# PERMIT

## SEWAGE DISPOSAL SYSTEM

SUBDIVISION Brantwood 2/2 LOT 2 ROAD 3113 Argent Path

<b>CLARK • FINEFROCK &amp; SACKETT, INC.</b> ENGINEERS • PLANNERS • SURVEYORS 7135 MINSTREL WAY • COLUMBIA, MD 21045 • (410) 381-7500 BALT. • (301) 621-8100 WASH.	
		DESIGNED DRAWN <b>KWC</b> CHECKED PAS DATE <b>8-22-01</b>	LOCATION DRAWING <b>3113 ARGENT PATH</b> <b>LOT 2</b> <b>BRANTWOOD</b> SECTION TWO AREA TWO LOTS 1 THRU 16 AND PRESERVATION PARCEL 'G' A RESUBDIVISION OF PART OF "BRANTWOOD-SECTION ONE NON-BUILDABLE BULK PARCEL 'E'" THIRD ELECTION DISTRICT HOWARD COUNTY, MARYLAND

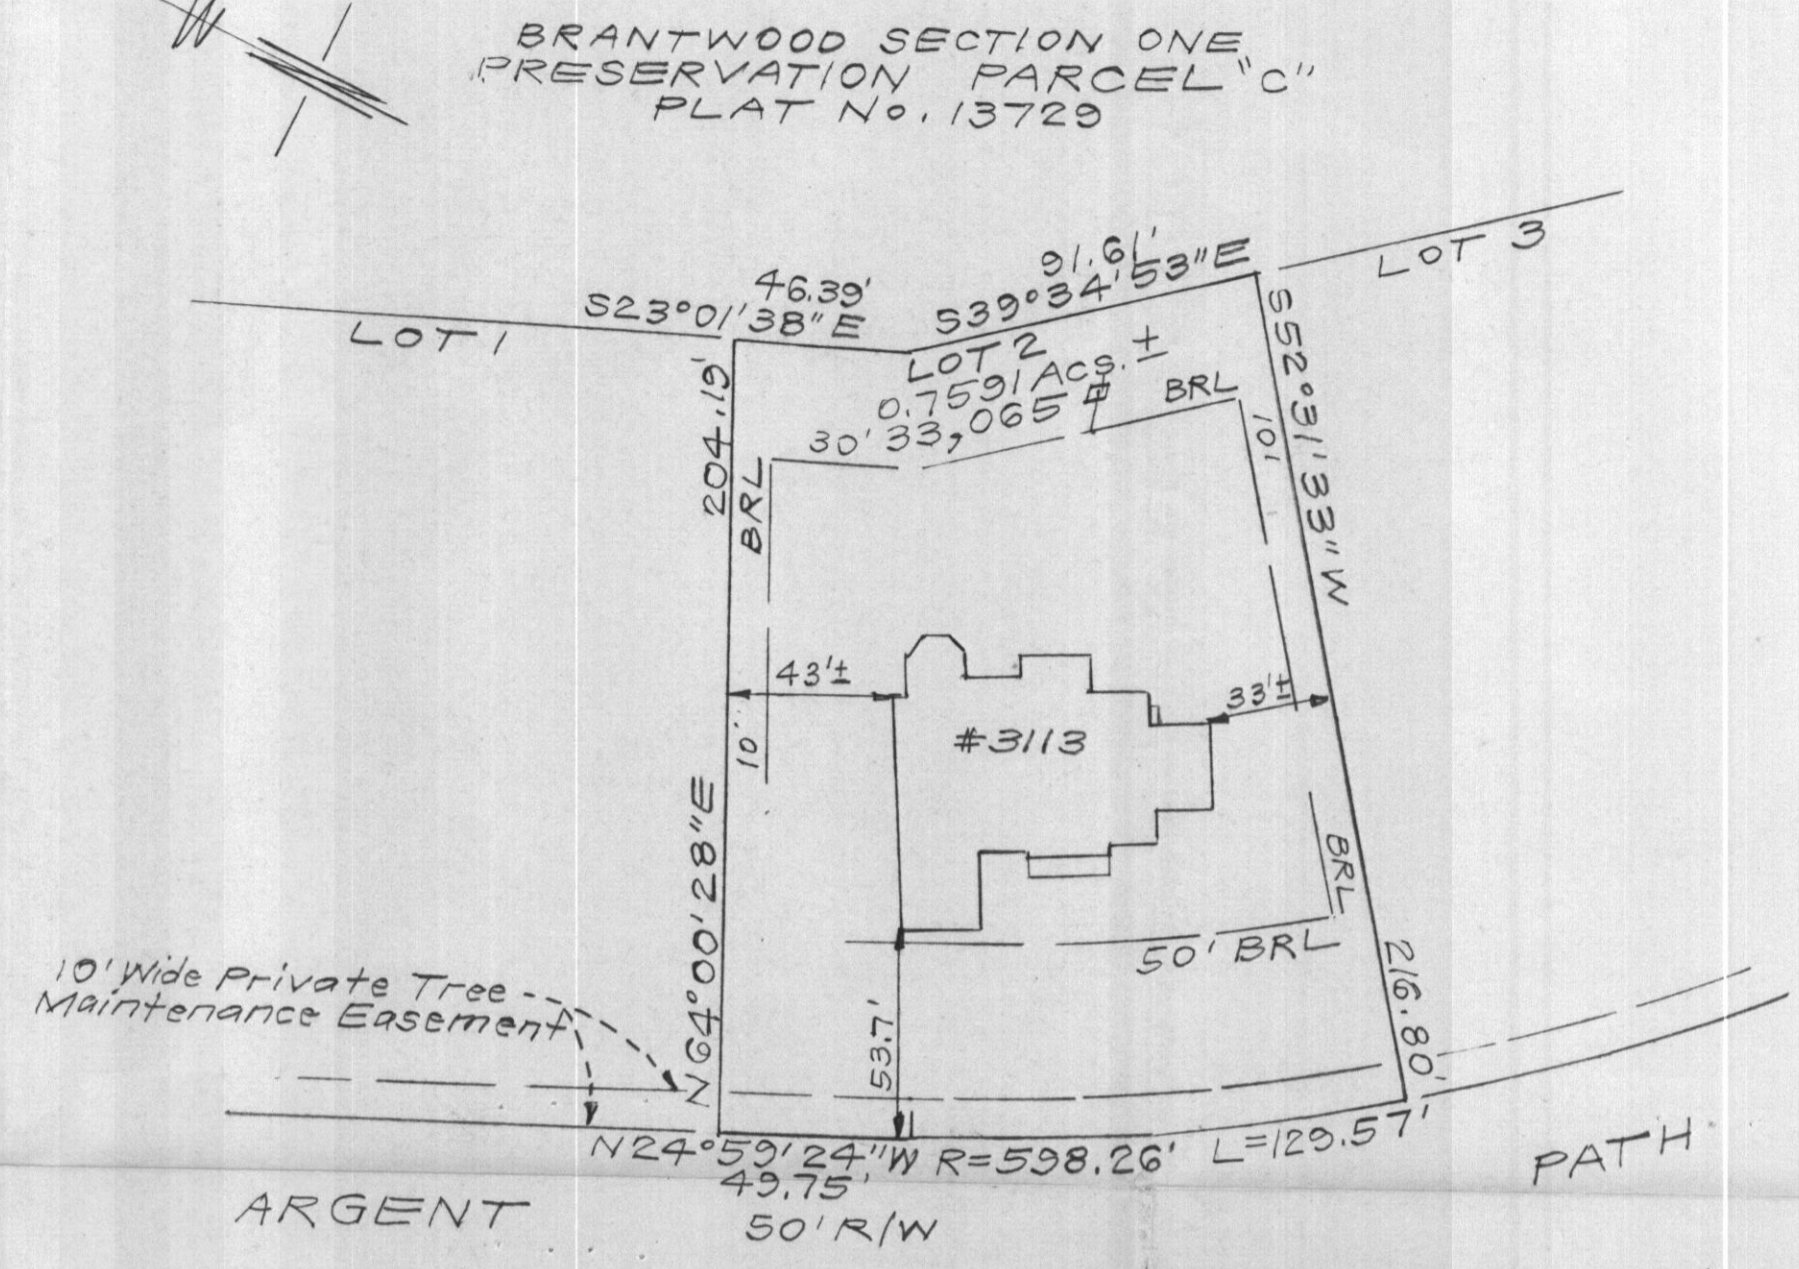
REMARKS: 11/13/01- CONNECTION OK, MATT TUDER FROM HO. CO. BUREAU OF  
UTILITIES PRESENT & WAS SATISFIED W/ CONNECTION INTO MAIN AT  
STREET, RECEIVED FAX FROM MATT TUDER VERIFYING BUREAU OF UTILITIE  
APPROVAL, WELL LINE CROSSES UNDERNEATH SEPTIC L  
I MENTIONED TO PLUMBER & BUILDER THAT THIS METHOD OF INSTALLATION  
IS NOT PREFERRED BUT ACCEPTABLE ACCORDING TO THE CURRENTLY ADOPTED  
2000 NSPC (NATIONAL STANDARD PLUMBING CODE), SEPTIC LINE IS CAST IRON

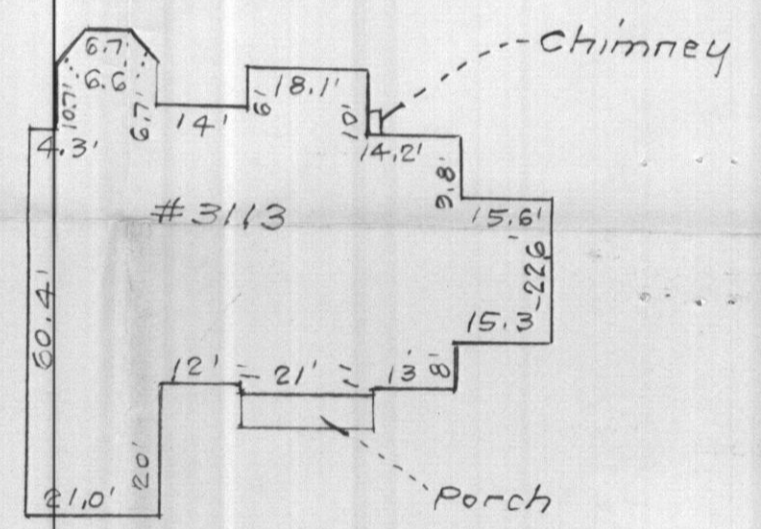
10/18/01  
House moved 15'  
toward rear lot line.  
No effect on well or  
septic. (BB)
